PRELIMINARY PLAT AMENDMENT STAFF REPORT WOODS AT VENICE

19-33PP

REQUEST: Preliminary plat amendment petition to request modification of the landscape plan that was approved with the original subdivision for the Woods at Venice, now known as Venice Woodlands.

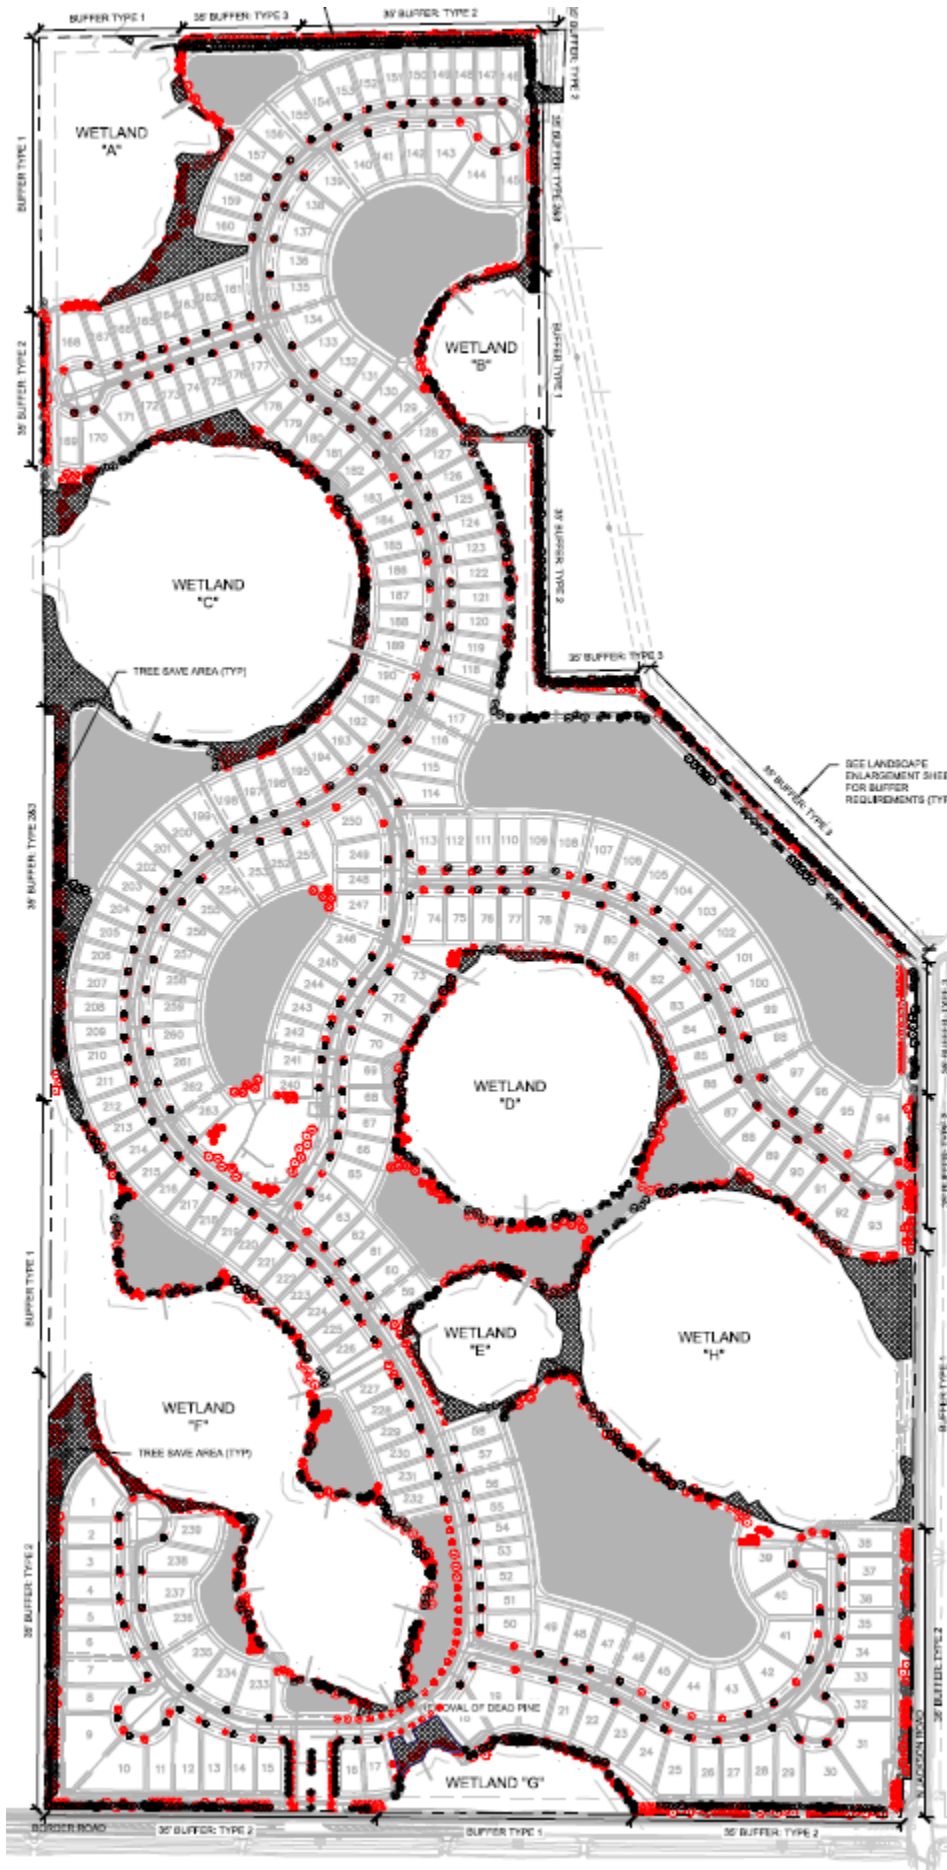
The proposed plan also identifies areas to be planted interior to the development that will now be relocated to the perimeter buffer areas. Relocation of these planting areas will provide for a more significant buffer to achieve the required 80% opacity. There is a graphic depiction on page 5 of this report of the approved vs. proposed landscape plans that was also included in the agenda packet.

Tree Save Areas Map

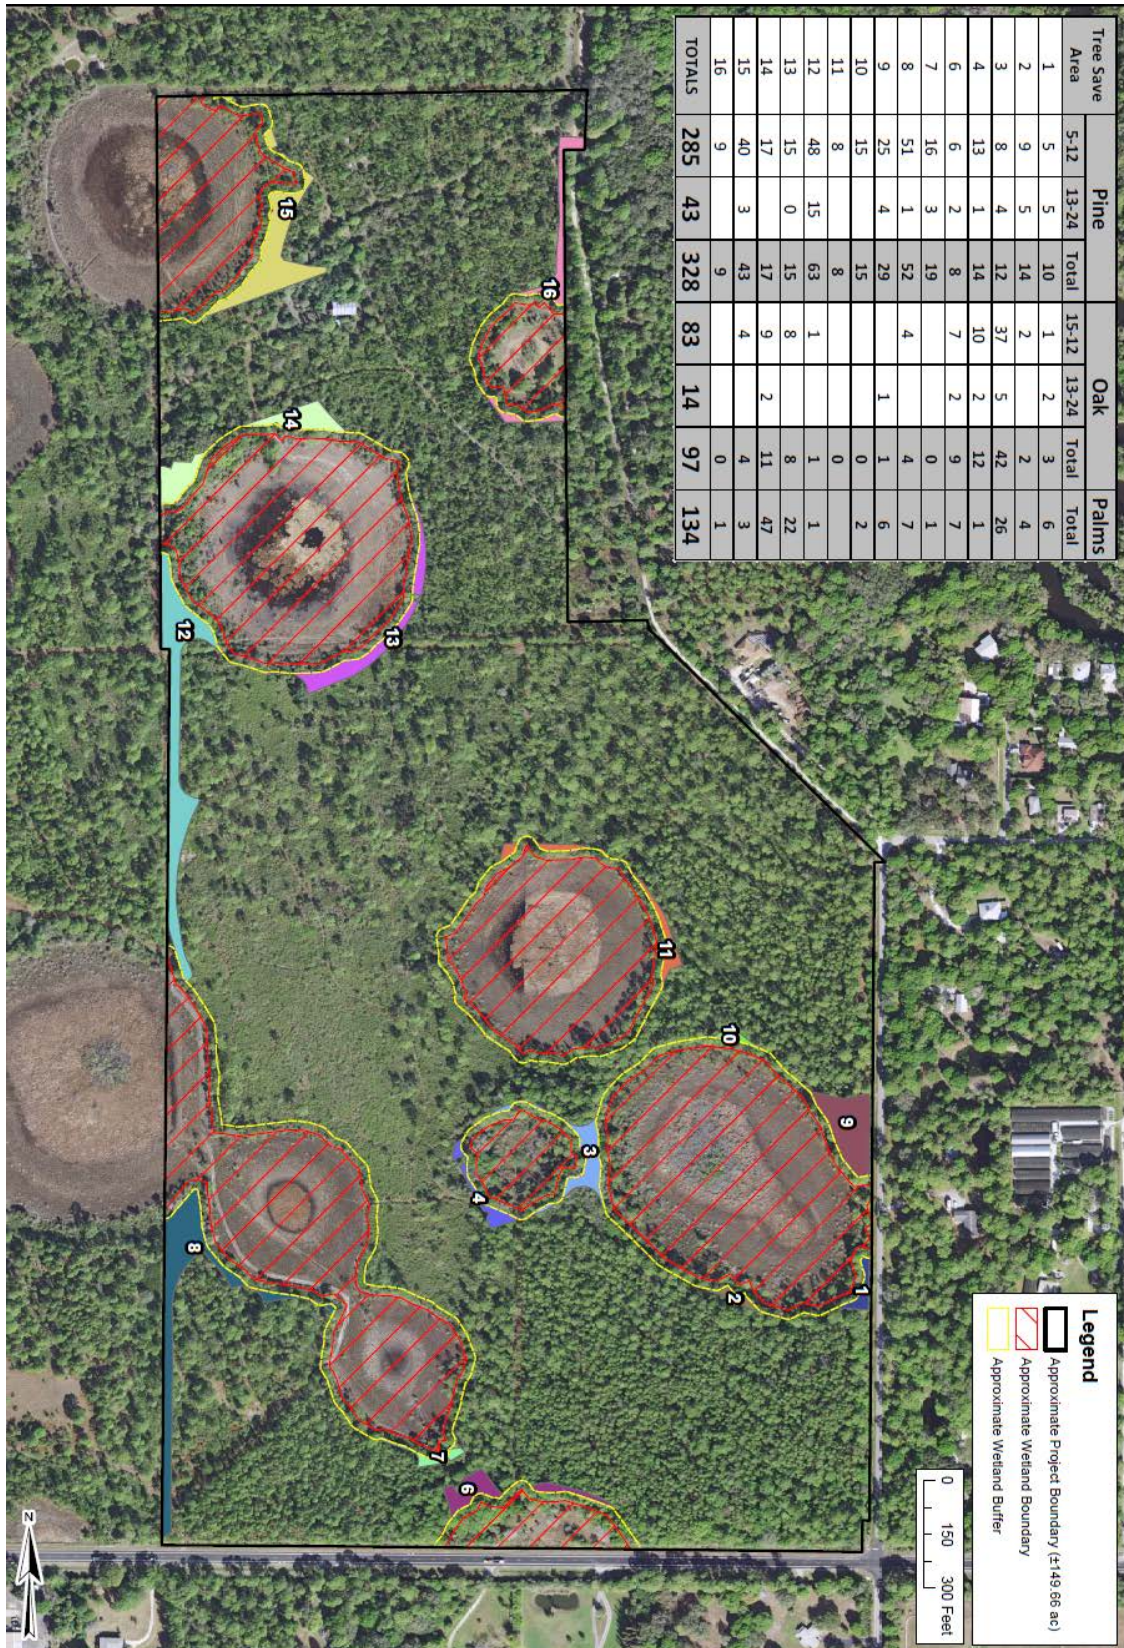
The applicant has provided with their submittal, a “tree save areas map” (see page 6) that depicts the areas of the project where mature trees will be maintained. These areas are mostly along the perimeter of the project and along the interior boundaries of wetlands to provide a larger, more mature buffer. There are no trees required along the perimeter adjacent to wetlands. Therefore, the existing trees interior to these wetland areas will provide visual screening from offsite. The aerial graphic provided by Eco Consultants, Inc. indicates maintaining 328 pine trees, 97 oaks and 134 palm trees.
